Product Safety Recall

N202325160 Battery Cable Short Circuit

Release Date: April 2021

Revision: 02

5779103

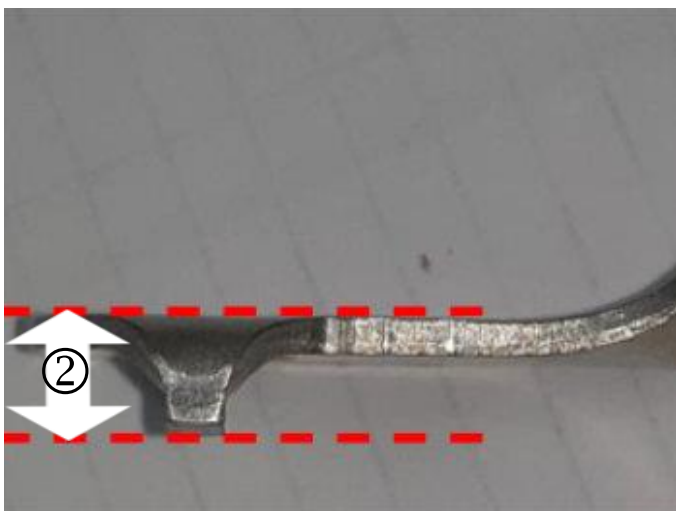
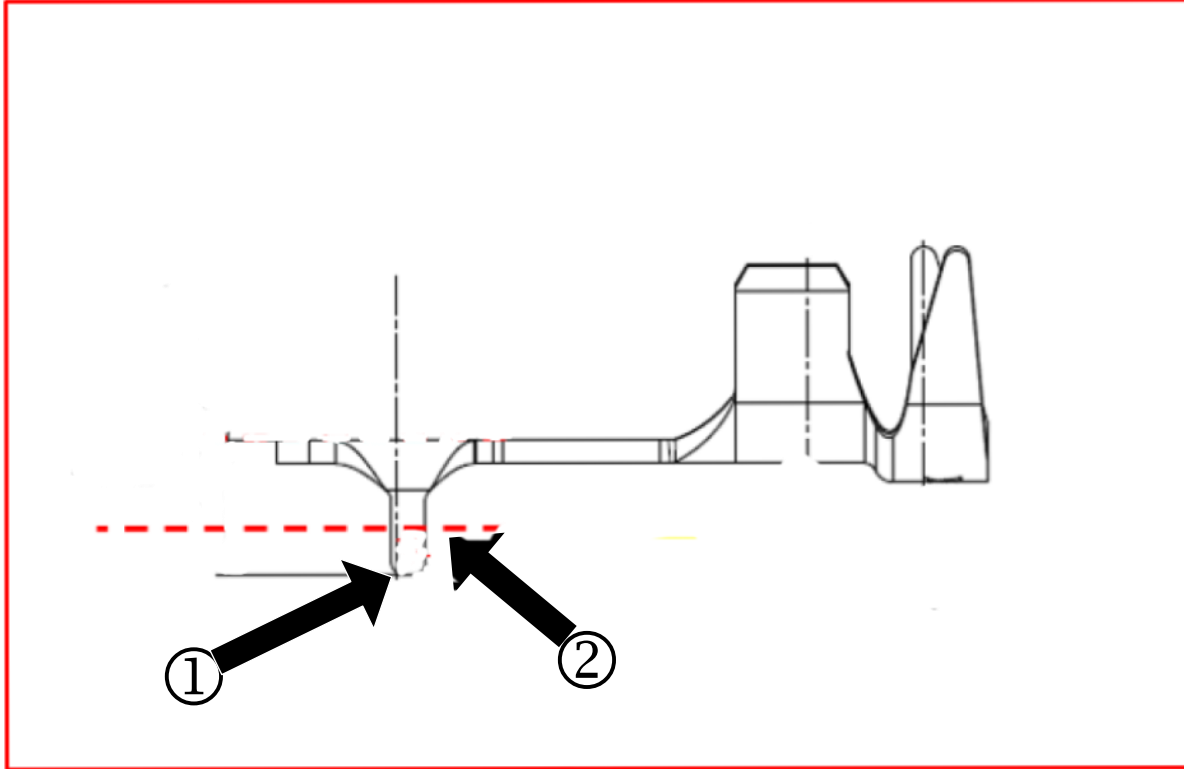
5. With the cables disconnected, locate the anti-rotation tabs on both cable ends.
6. Inspect the length of the terminal anti-rotation tabs on both cable ends.

- If one or both anti-rotation tabs has been cut completely off or is trimmed to less than 6mm in length (2), the battery cable assembly will require replacement. No service parts are available currently.
- If both anti-rotation tabs have not been cut, proceed to steps 7-15 below.

5779100

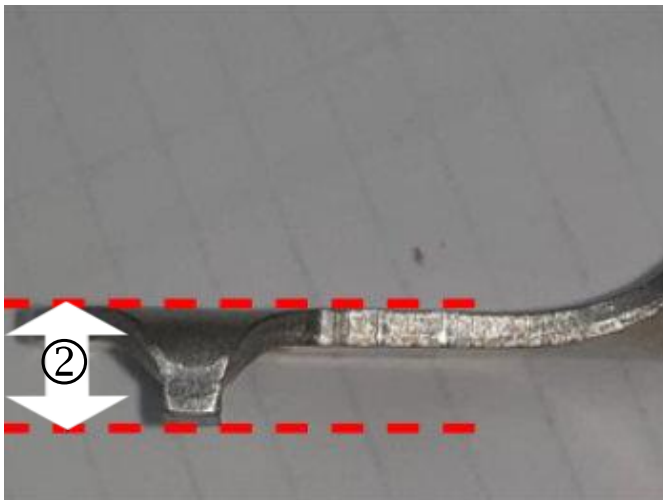
Important: The following measurement is critical to a correct repair. THE CUT MUST BE MADE IN THE EXACT LOCATION SHOWN IN THE GRAPHIC. DO NOT cut the anti-rotation tab flush. Cutting the tab flush may cause the cables to rotate and contact the fasteners or the Mega fuse mounting studs.

7. Starting from the bottom of the tab (1), measure up 4.5mm (2) from the end of the tab and scribe a line.

- Using cutters, cut on the scribed line. Use care to only remove the correct amount of the tab. DO NOT remove the complete tab.

5779103

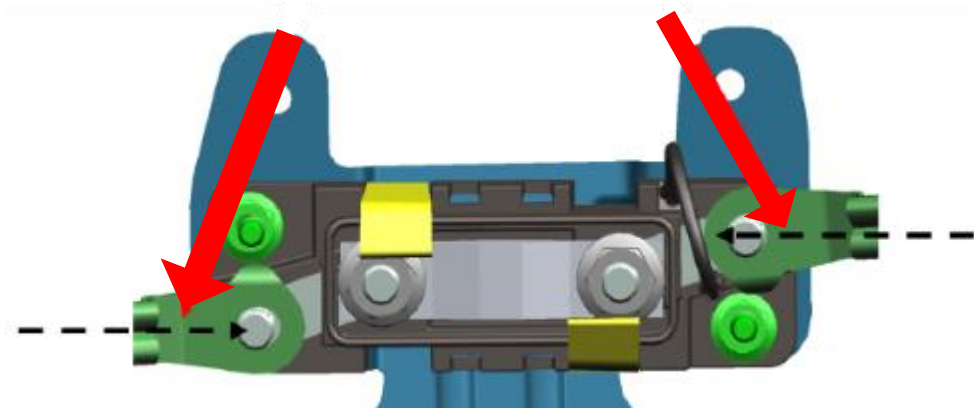
- The completed trimmed terminal should have a total height of 6mm (2).
- After the tab is cut, ensure the tab is 90 degrees to the lug. Adjust as required by slightly bending the tab.
- Repeat the above steps on the second cable.
- Loosely reinstall the two cables.

5779108

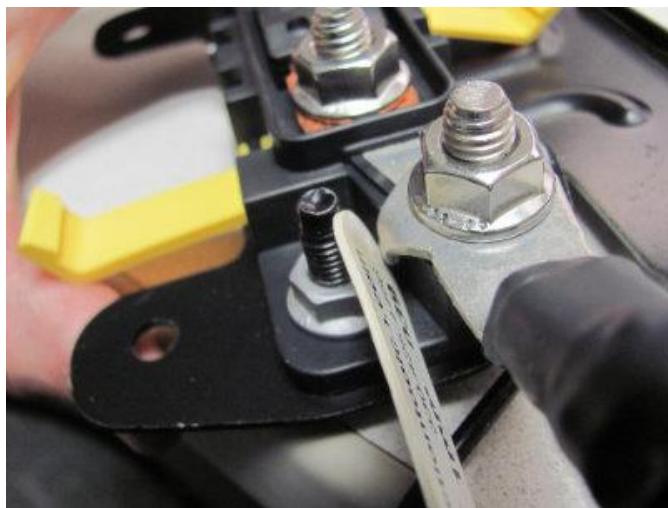
IMPORTANT: With both fasteners tightened to specification, **make sure there is at least 1mm clearance** between the anti-rotation tab and the nut at both locations. If the clearance is less than 1mm, remove the cable and further trim the tab as required.
